WHITE TAIL CROSSING BRIDGE
I-395/ROUTE 9 CONNECTOR
BREWER – EDDINGTON, ME
MEDOT
WIN 018915.50
STATE OF MAINE
MEDOT
N/A
SPECIAL PROVISION SECTION 534
PRECAST STRUCTURAL CONCRETE
WHITE TAIL CROSSING BRIDGE
SHEET 4 OF 7
N/A
CONCRETE SYSTEMS INC.
C24548

STATE OF MAINE WHITE TAIL CROSSING BRIDGE BREWER — EDDINGTON, ME			
D	CULVERT LAYOUT PLAN & SIDE ELEVATION		REV 1
	Drawing No. C24548-LO3		
Quantity: —	Project No: WIN 018915.50	SHEET 2	OF 16

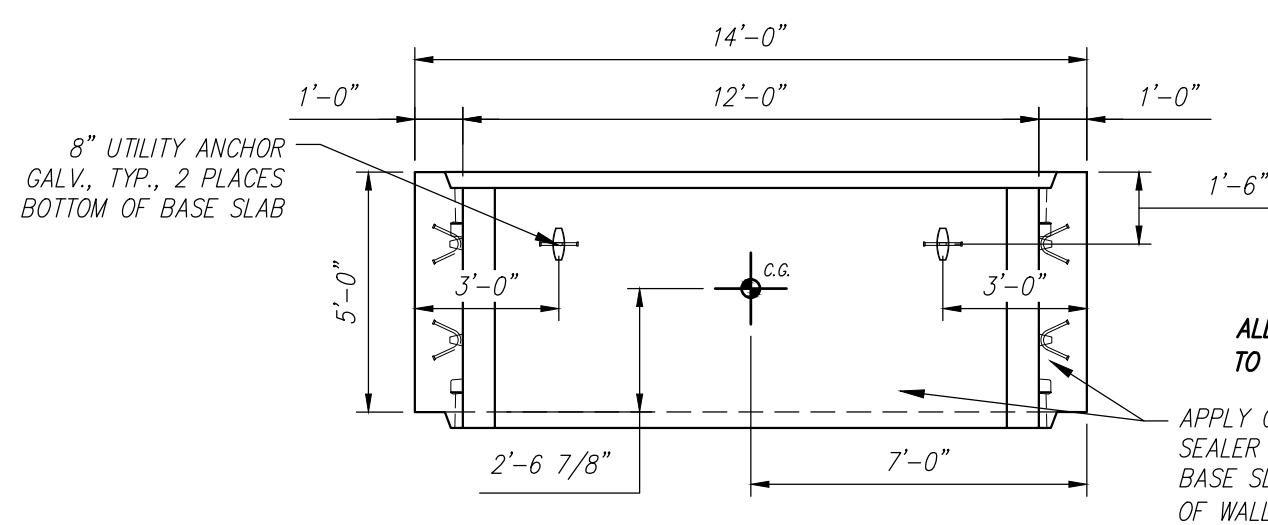
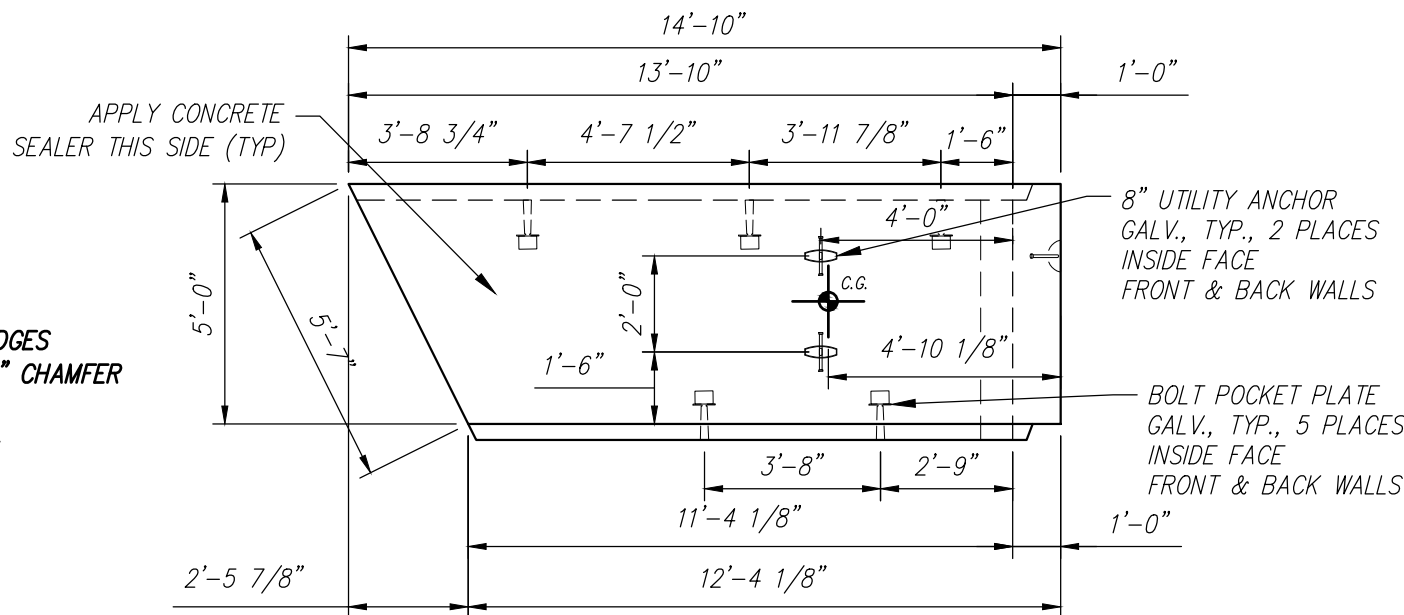
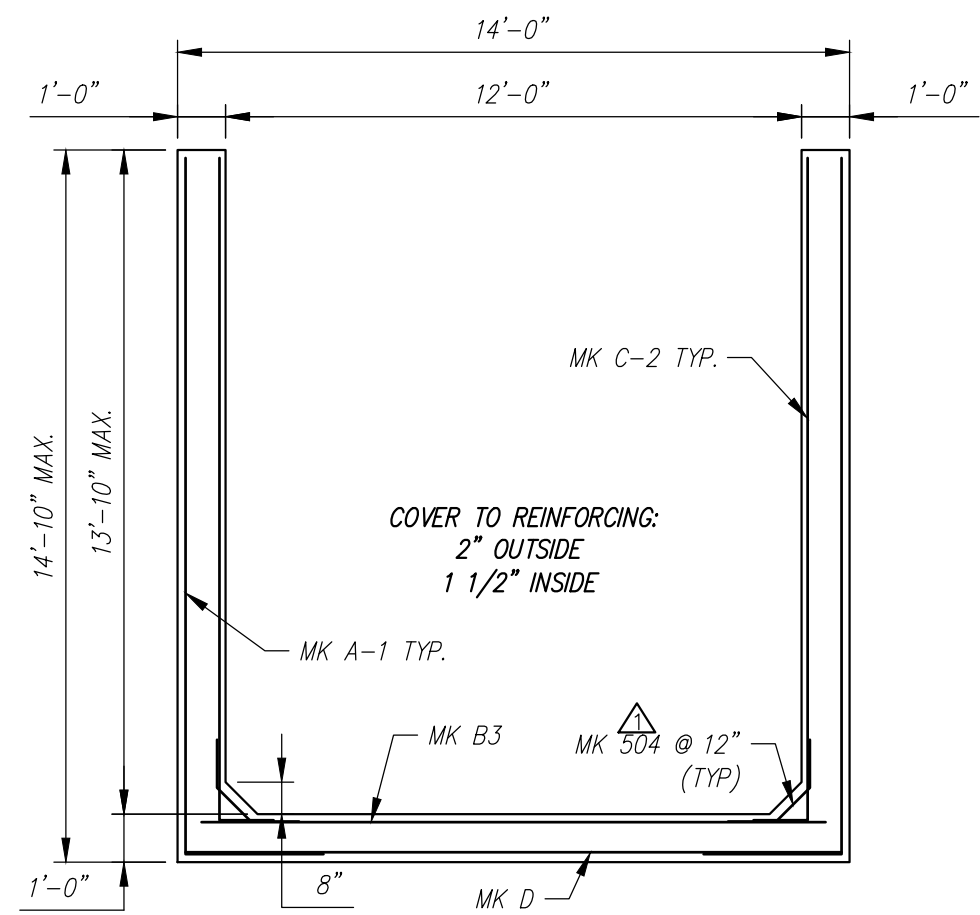
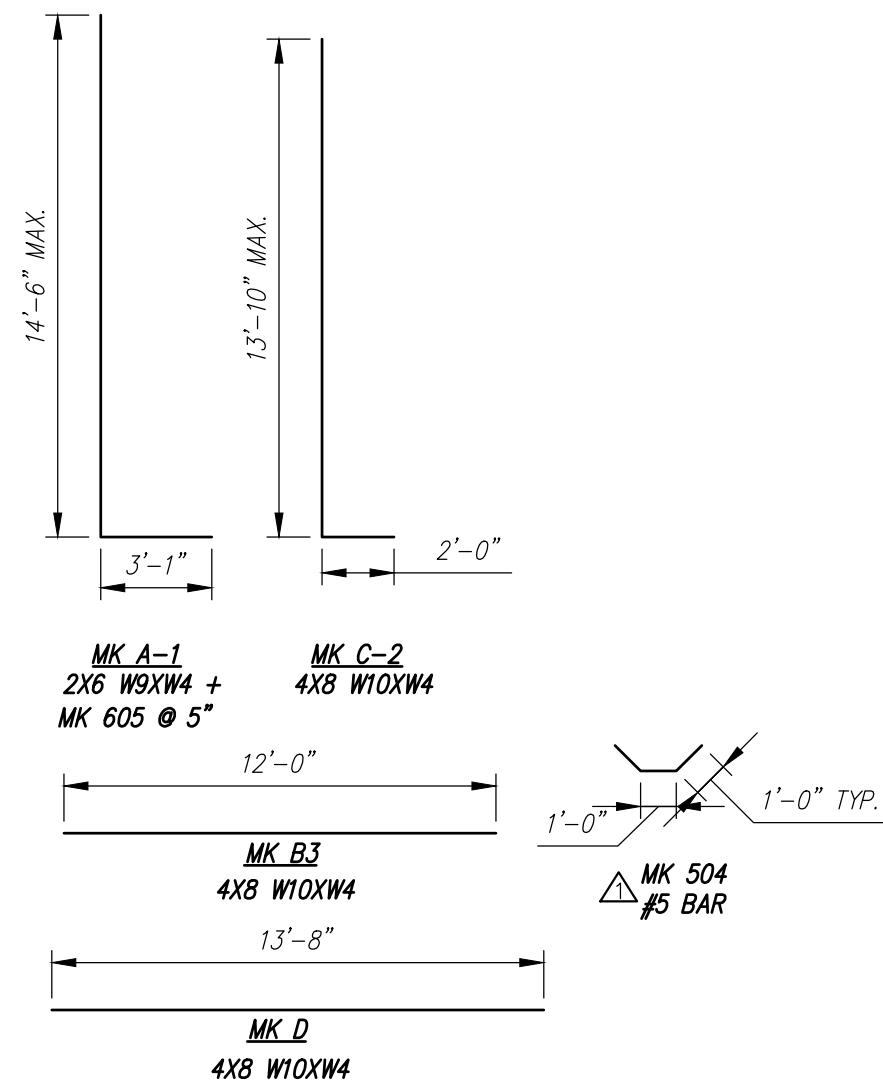
9						MEDOT	STATE OF MAINE WHITE TAIL CROSSING BRIDGE BREWER — EDDINGTON, ME								
		8							Drawing No. INDIVIDUAL PIECE SHOP DRAWING C9								
		7								Drawing No. C24548-C9							
		6									Drawing No. C24548-C9						
		5										Drawing No. C24548-C9					
		4											Drawing No. C24548-C9				
		3												Drawing No. C24548-C9			
		2													Drawing No. C24548-C9		
		1	09/14/2021	REVISED REINFORCING	YAA											Drawing No. C24548-C9	
	Rev.	Date	DESCRIPTION	By	Drawing No. C24548-C9												
			REVISIONS			Drawing No. C24548-C9

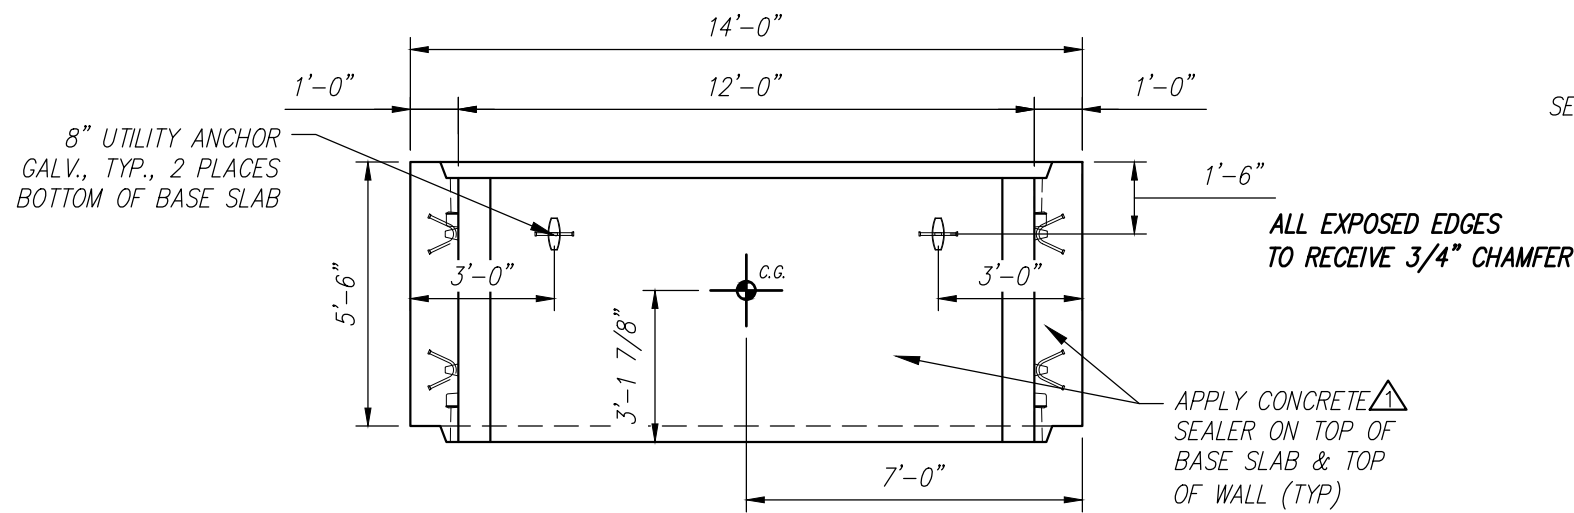
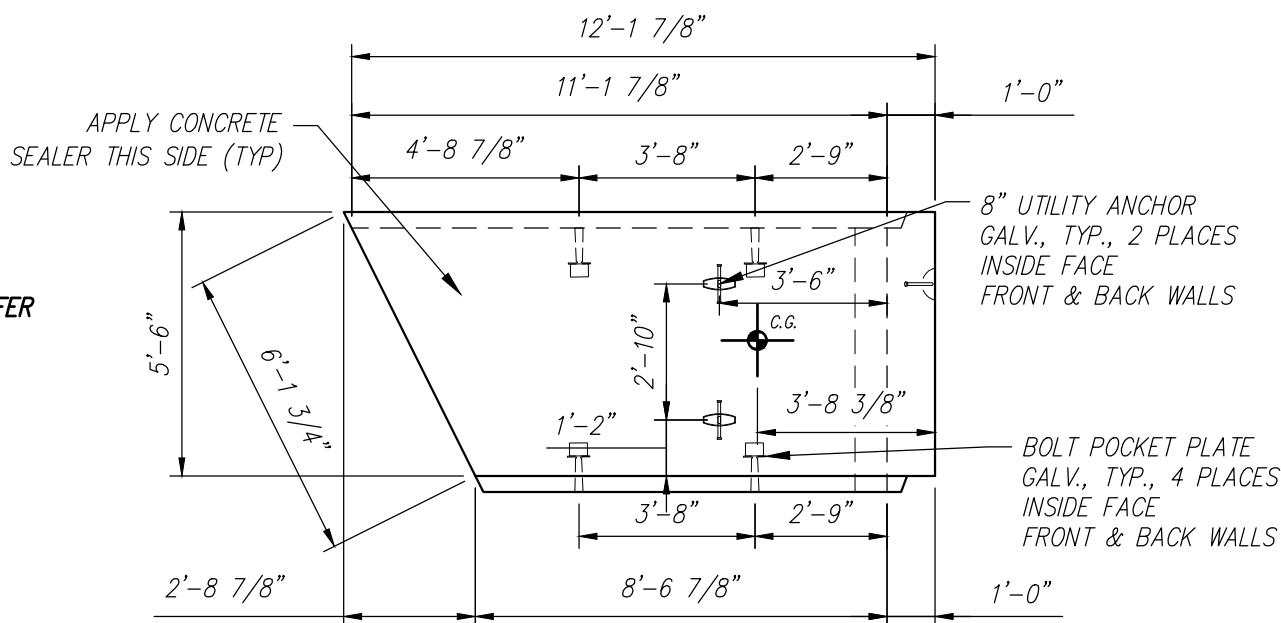
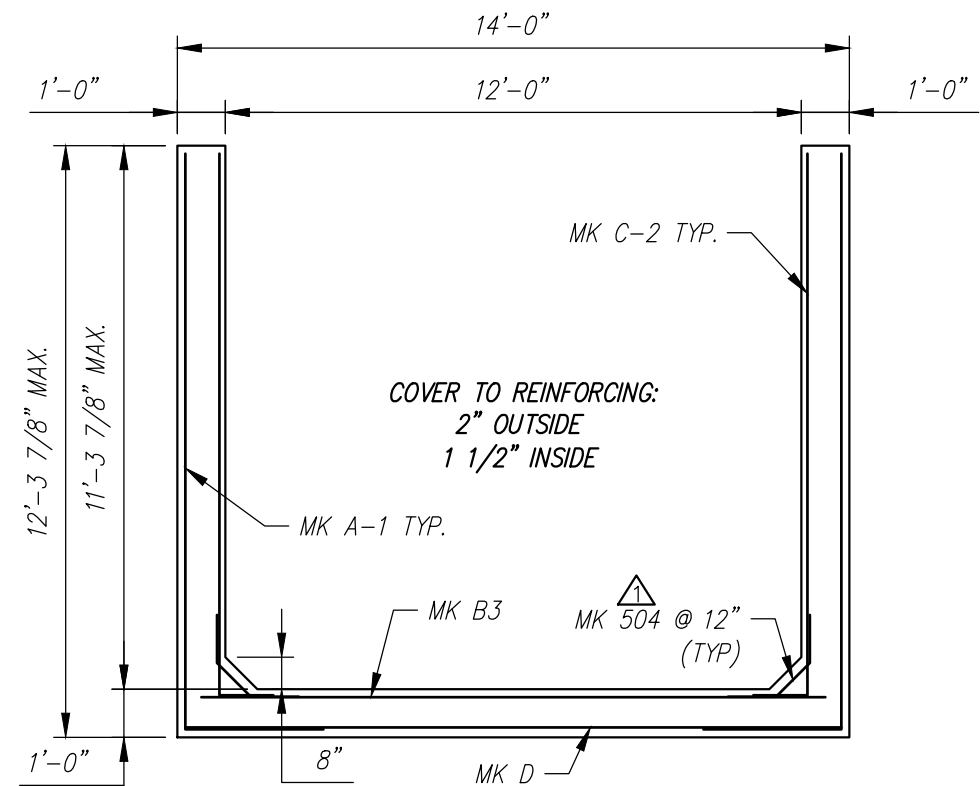
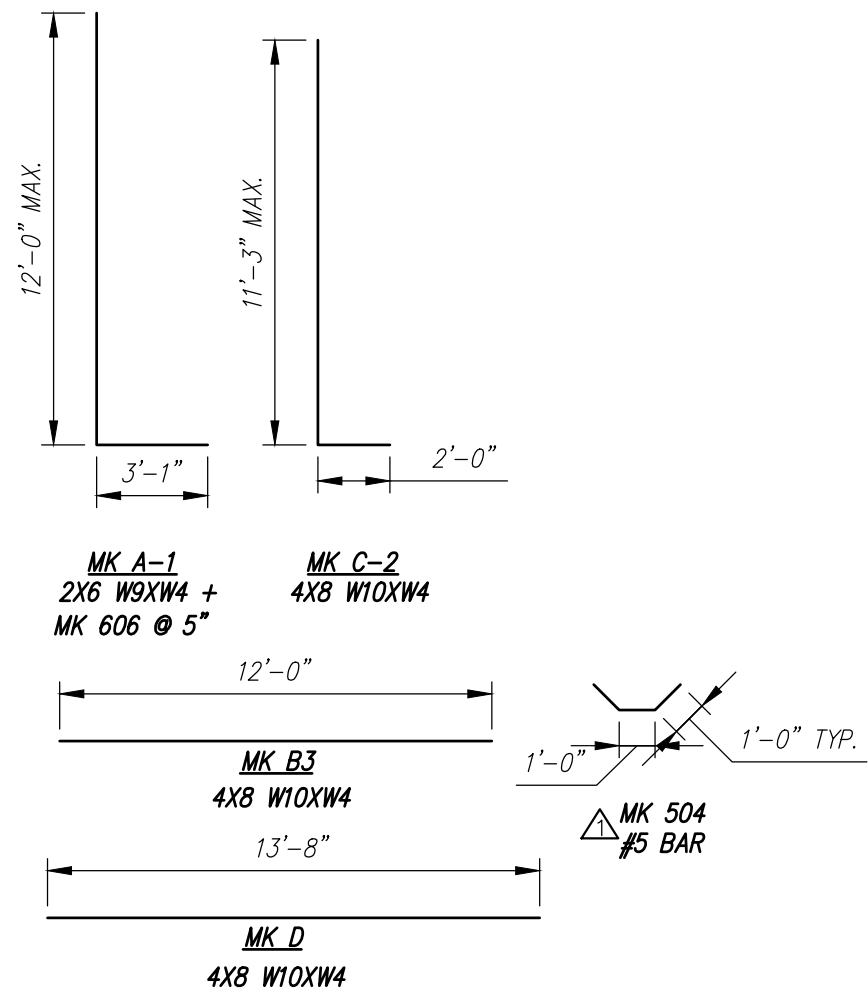
9						MEDOT							
		8													
		7													
		6													
		5													
		4													
		3													
		2													
		1	09/14/2021	REVISED REINFORCING	YAA										
This drawing contains information proprietary to CONCRETE SYSTEMS, INC. This drawing is disclosed with the understanding that it will be retained in confidence and its use limited solely to the purpose for which it is disclosed. It is understood that no reproduction of this drawing is authorized without permission from CONCRETE SYSTEMS, INC. and that it will be returned to CONCRETE SYSTEMS, INC. upon request.	Rev.	Date	DESCRIPTION	By											
	REVISIONS														
							Drawn By YAA		Date 08/17/2021	D		INDIVIDUAL PIECE SHOP DRAWING C10		REV 1	
							Reviewed By YAA		Date 08/18/2021	Drawing No. C24548—C10					
							Approved By		Date	Quantity: 1		Project No: WIN 018915.50		SHEET 14 OF 16
